4-WIRE SINGLE FREQUENCY/FOREIGN EXCHANGE (4WSF/FX) CHANNEL UNIT, 628278

GENERAL DESCRIPTION

1.001 This addendum supplements Section ITTR-18-278, Issue 1, in Operation-Installation-Maintenance Manual for D448 PCM Trunk Carrier System, Publication Number 650059-823-001. Place these pink sheets ahead of Page 01 of the Section.

1.002 This addendum is issued to revise Fig. 1, to add Table H, to add information on Groups -002 and -003, and for Common Language Equipment Identification (CLEI) coding.

Fig. 1 -- 4WSF/FX Channel Unit, 628278

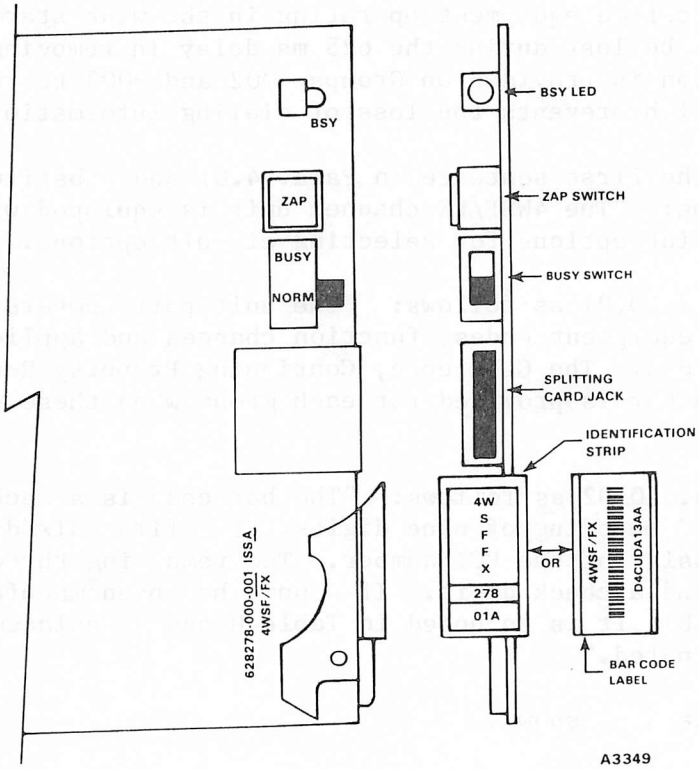
2.003 Delete existing Fig. 1 and substitute the following:
